[PAPER TRAY UNIT]

6.3 Tray Unit Drive and Paper Feed Clutch Replacement (page 21) (Call outs of the illustration)

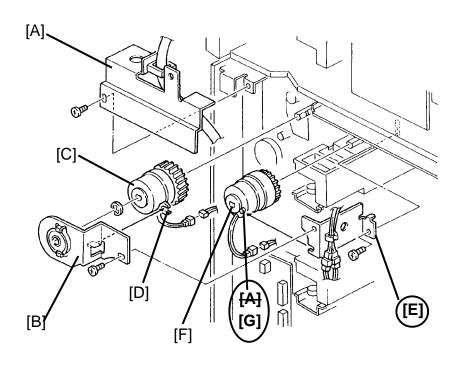
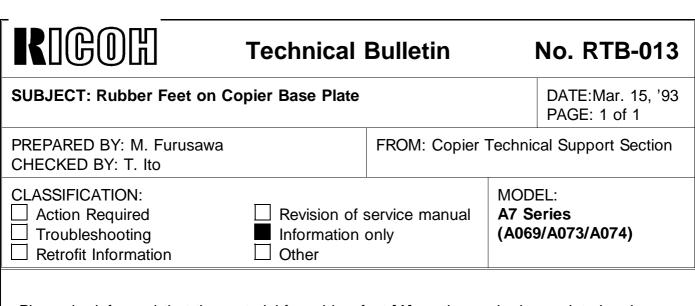
Please be informed that the material for rubber feet [A] on the copier base plate has been changed from hard rubber to molding since June, 1992.

When the copier is installed on the paper tray unit, the rubber feet are compressed by the copier's weight and they may be shortened.

When this occurs the gear mesh between the tray unit drive and driven gears [B,C] becomes tight, causing noise.

To prevent this, the material of the feet has been changed to a hard one. The part number has not been changed.

However, in case that the copier is installed on a normal commercial table, please note that the copier may slip on the table rather easily with the new feet.

If the copier slips easily on the table, it is advised to stick rubber plates on the feet by glue or two sided tape for safety. You can use a commercial rubber plate and cut it for the feet.
